Piper Aircraft, Inc. 2926 Piper Drive Vero Beach, FL, U.S.A. 32960

SERVICE NO. 1372 BULLETIN

Date: April 3, 2024

MAIN WING SPAR INSPECTION

Figure 1 (Sheet 1 of 2) Typical Main Wing Spar Attach Bolts and Spar Cross Section (Right Wing Shown)

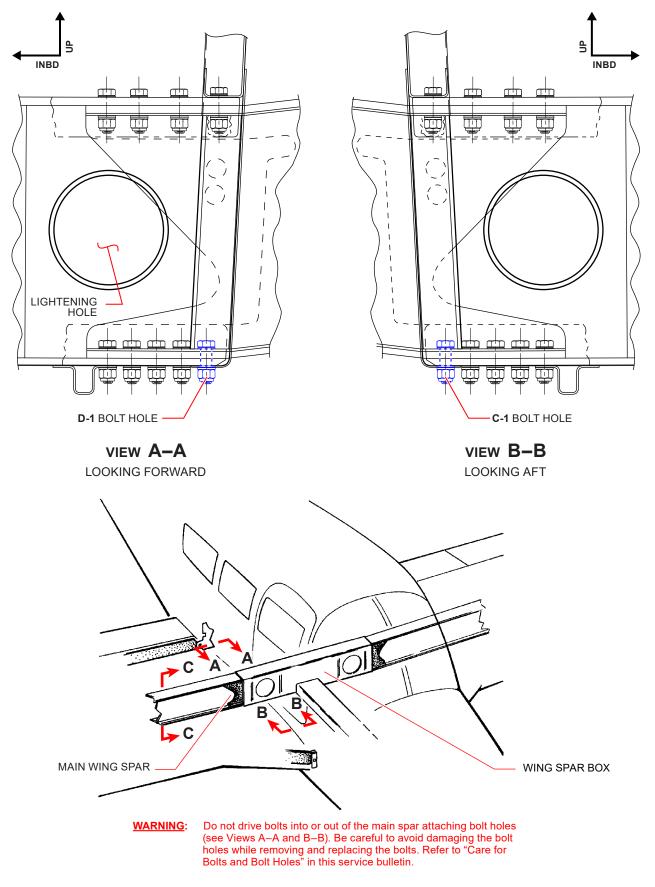
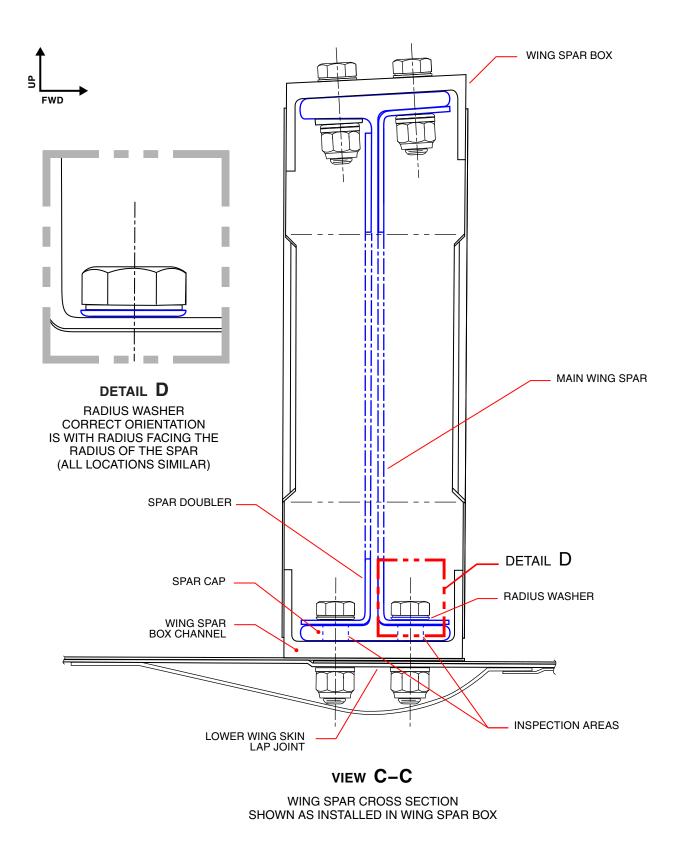
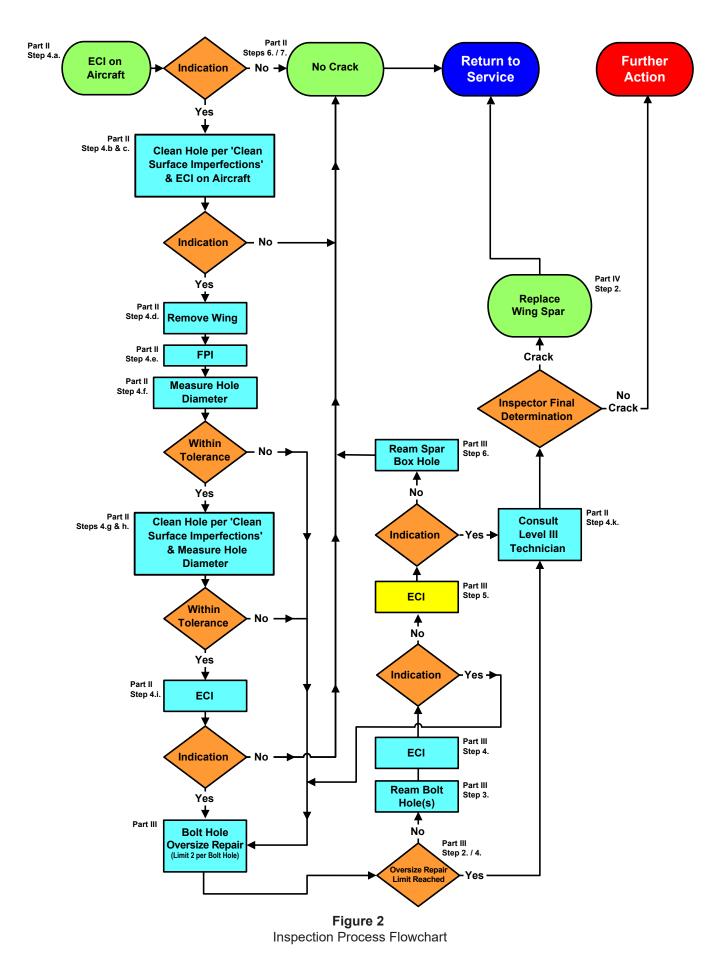
- 2. Locate the two (2) outermost main spar attach bolts, as shown in Figure 1, installed on the lower cap of the left and right main spar, on the forward and aft sides of the spar web.

- <u>NOTE</u>: When radius washers are properly installed, the radius feature of the washer will be oriented to match the radius of the adjacent structure, as shown in Figure 1, Detail D.

- 4. RC Inspect the inner surface of each bolt hole in the lower wing spar cap. Figure 1 provides cross sections of the main wing spar, and identifies the bolt hole inspection areas.
